NSW GOVERNMENT
Department of Planning

***MAJOR PROJECT ASSESSMENT:
Auburn Hospital Redevelopment
Major Project No. 06_129***

Director-General's
Environmental Assessment (EA) Report
Section 75I of the *Environmental Planning and
Assessment Act 1979*

January 2007

Figure 9 – Proposed Loading Dock Turning Circle

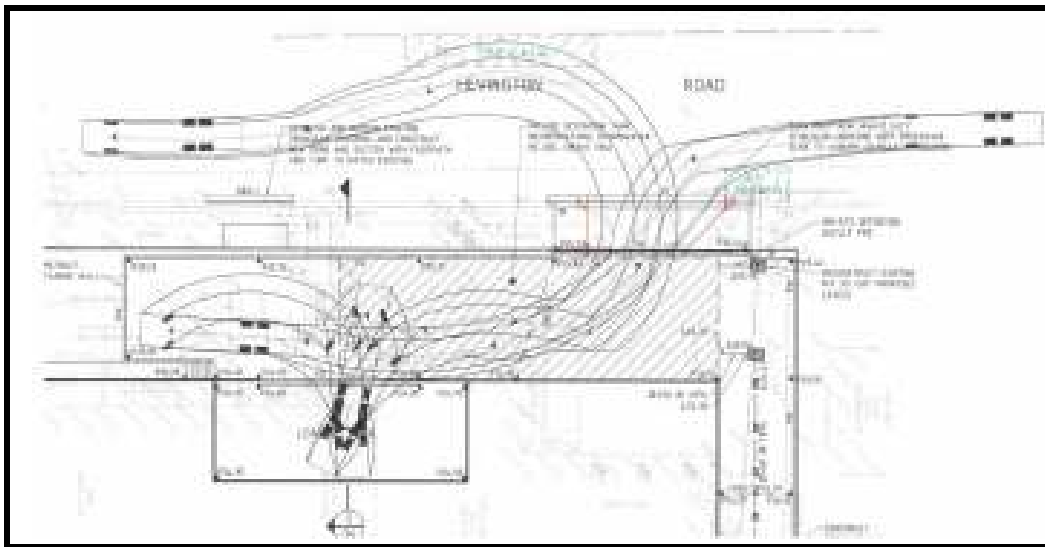
- 6.5.14 Nonetheless, Council is concerned that the proposed loading dock will prevent delivery vehicles from entering and exiting the site in a forward direction. To this end, Council has requested that the loading bay access be reduced to 8 metre width and all required swept paths be indicated by the proponent by way of new architectural design plans.

- 6.5.16 Council has requested a series of amendments to the proposal to ensure optimal traffic access and minimal disruption to residents. These include:
- Reduction of the Water Street access to 4 metres in width.
 - Deletion of the layback to the parking bay to facilitate access and screen the development from adjoining residential properties.
 - Widening of the entrance to the temporary car parking area adjacent to Norval Street together with provision of a median in the access.
 - All one way access layback crossings to be reduced to 4 metres in width.

- 6.5.15 The proponent is of the view that the proposed loading dock facilities will permit the forward movement of vehicles. The proponent has concurred with Council's comments concerning the loading dock access point and has reduced its width to the requested 8 metres with splayed kerb. Amended plans have been submitted with the preferred project report which clearly demonstrate that the loading dock and required turning circles can function with minimal or no disruption to existing road traffic (Figure 9), subject to "No Parking" signage being erected on the western side of Hevington Road in the vicinity of the loading dock's access point. **Condition No. B10** requires the installation of such signage in the required locations at full cost to the proponent.

- 6.5.17 The proponent has reduced the Water Street ramp and all one way access crossings to 4 metres width in the preferred project report, the only exception being the loading dock entry which will remain 8 metres wide. The proponent has also agreed that the driveway access to the Norval Street car parking area could be relocated with minimum driveway widths of 4 metres for one-way access points and 8 metres wide (including median) for two-way access points.
